Bid 579, MC Library Server Room HVAC Replacement Project – Addendum 1

VENTURA COUNTY COMMUNITY COLLEGE DISTRICT
 MOORPARK COLLEGE LLR BUILDING
 ADDENDUM #1

Sketch No.: MSK-001
 Print Date: 03/04/19

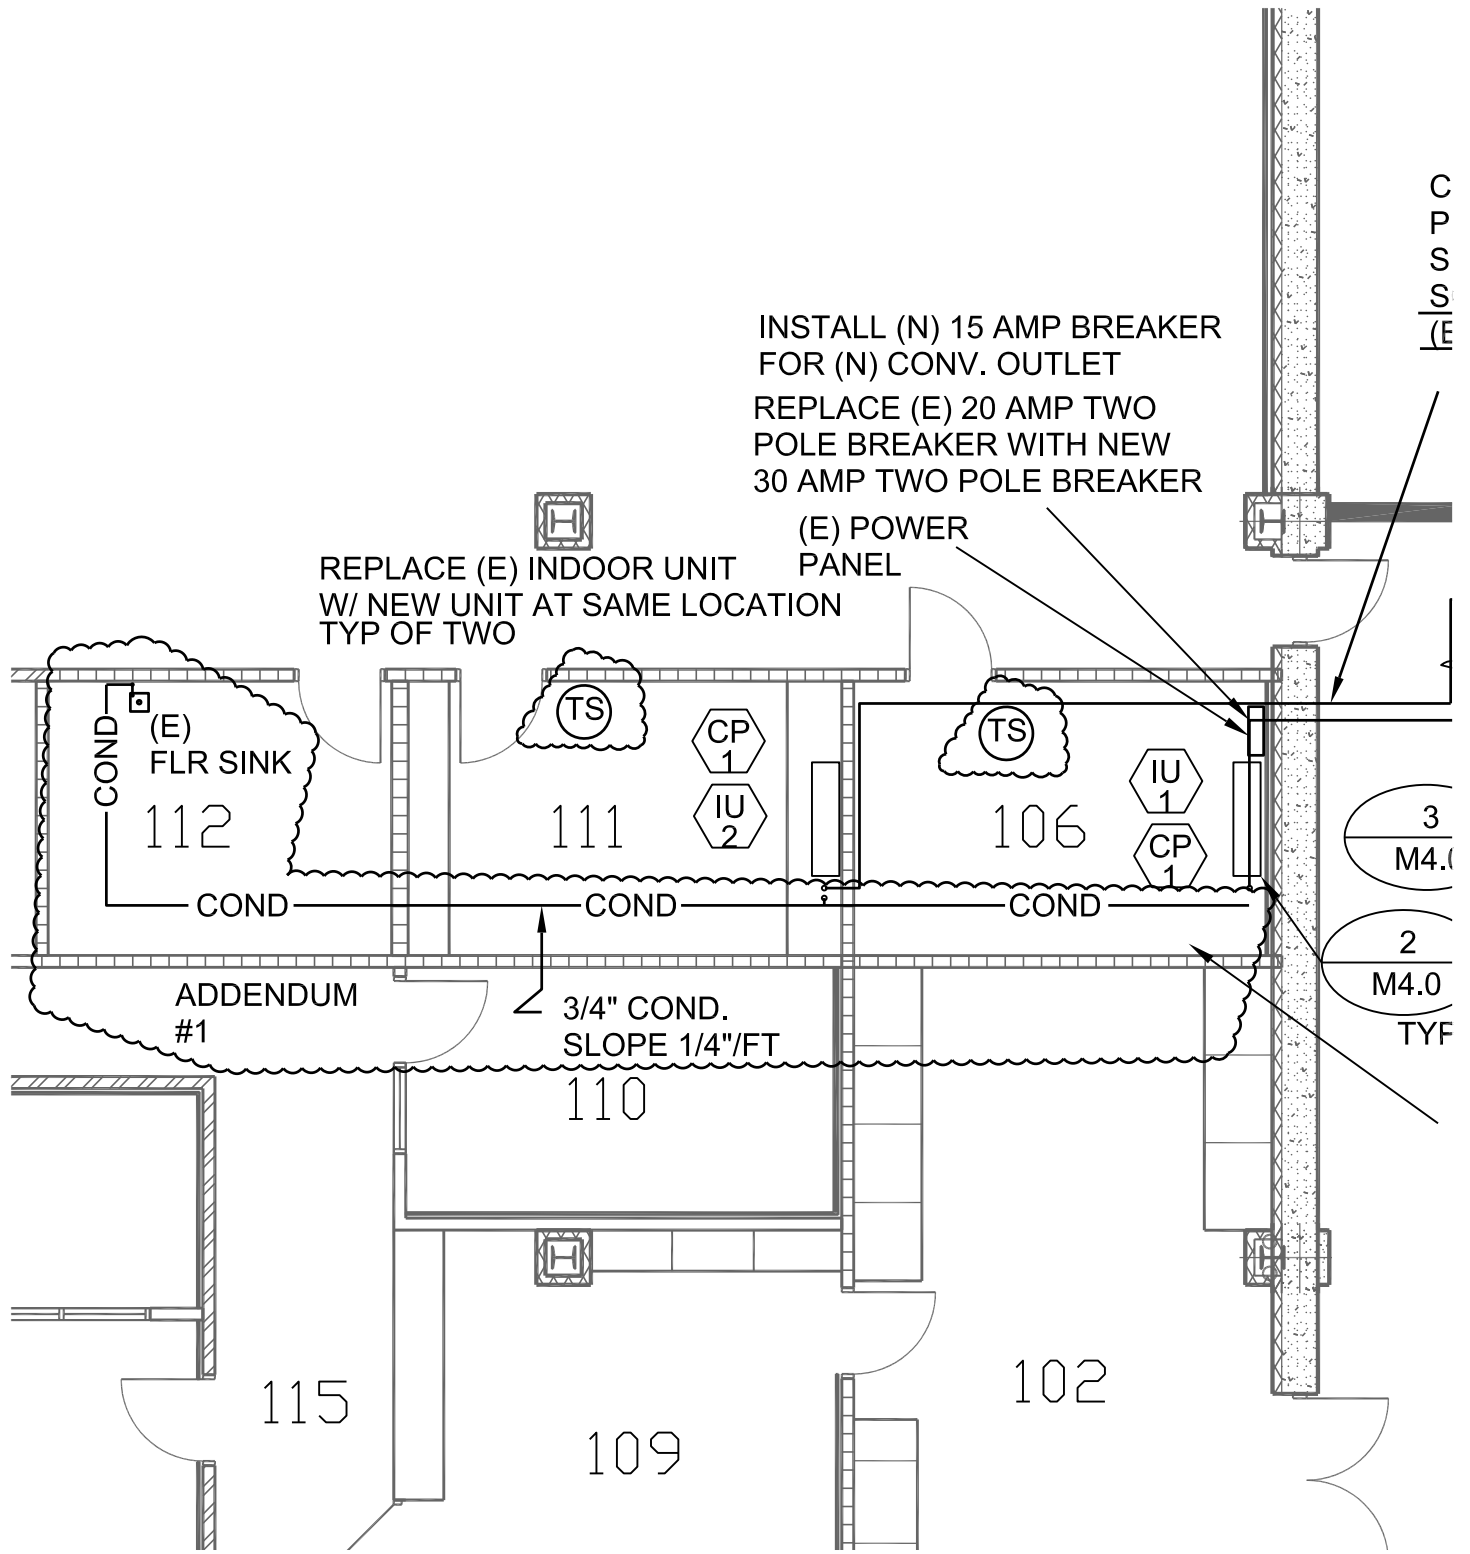
1. See the following Drawing called: Sketch No.: MSK-001, dated 03/04/19.

Shows the additional scope of work as discussed on the Jobwalk regarding Condensate Piping.

1. REPLACE (E) PLASTIC CONDENSATE TUBING WITH NEW 3/4" COPPER TYPE L CONDENSATE WITH CLEANOUTS. PROVIDE CONNECTION TO (N) PUMPS AND TERMINATION AT (E) FLOOR SINK.
2. ADD NEW TEMPERATURE SENSORS AT ROOMS 106 & 111 WITH CONTROLLER AND INTEGRATION INTO (E) AUTOMATED LOGIC SYSTEM WITH GRAPHICS AND ALARMS.
